Amendment, Permit # B16001935

I am requesting to amend Permit # B16001935 at 12103 Hayland Farm way  
to revise finished basement to include  
home office and a storage area (FINISHED)

12103 Hayland<sup>Park</sup> Way  
**CLIFTON PARK II**

B16001935 REVISED per Health

**SHEET NO.:** A-8  
**46.1**

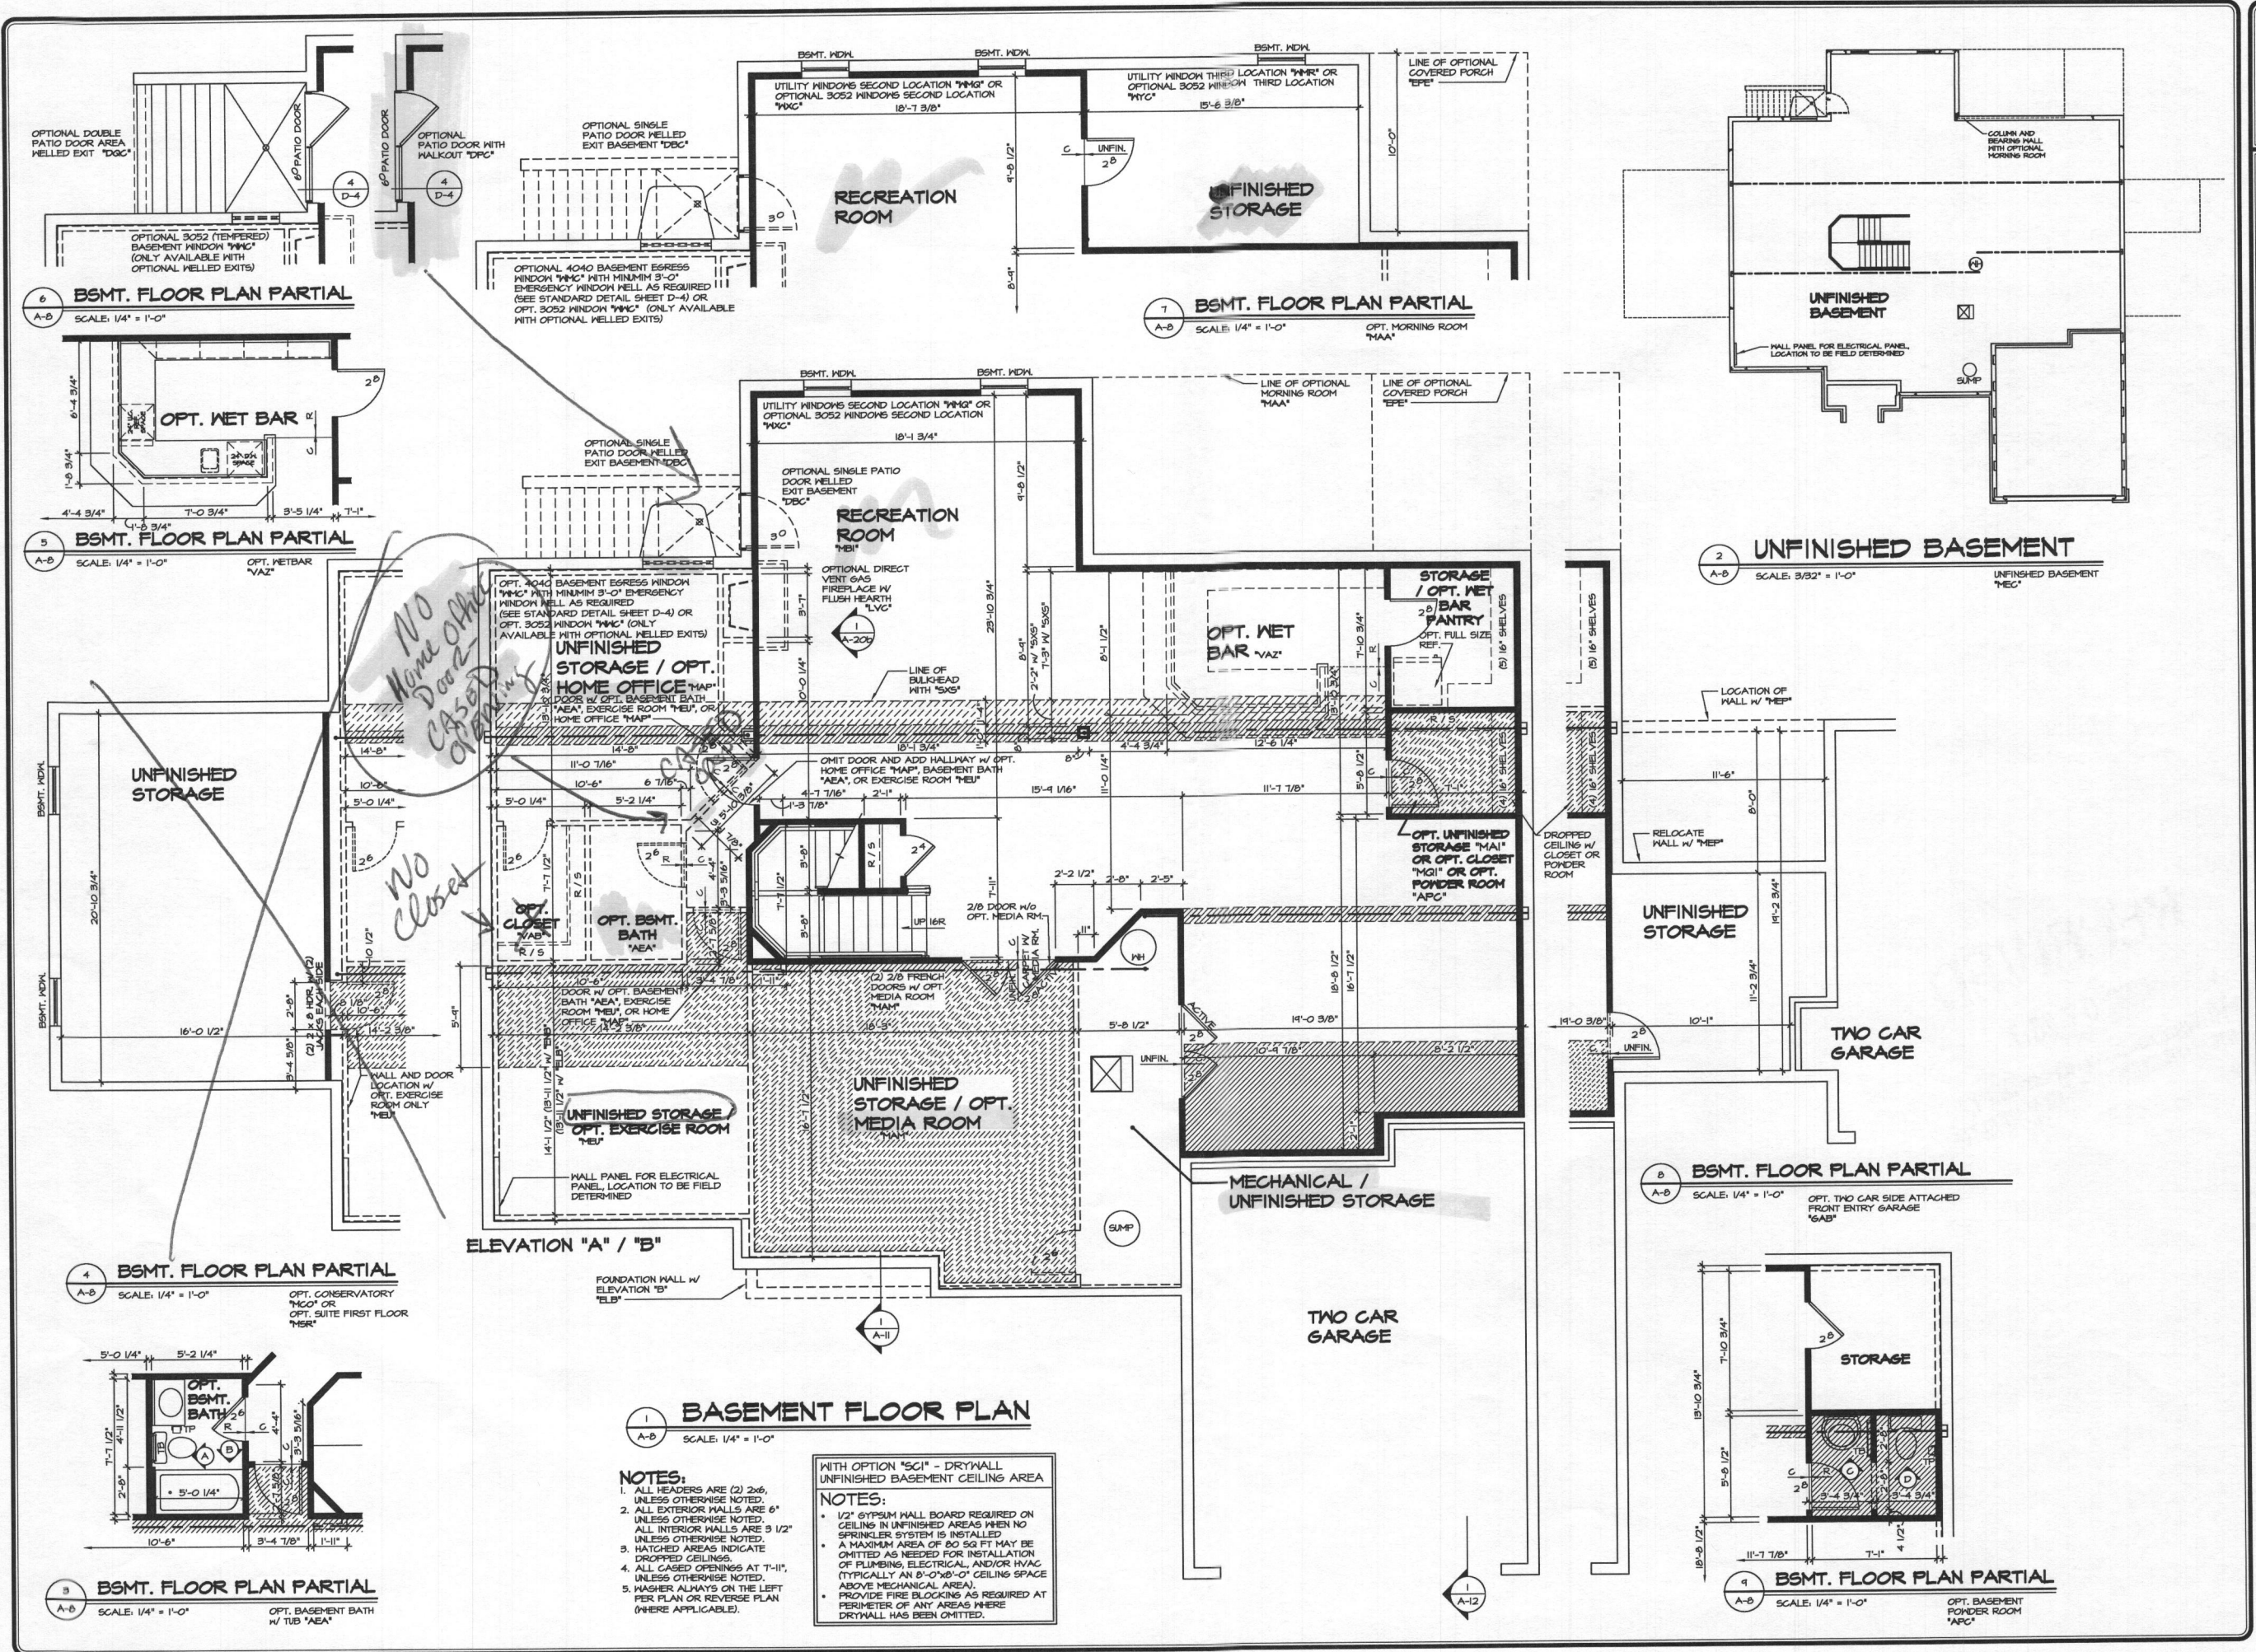
NO Home Office Doors - CASADY APPROVING

NO closet
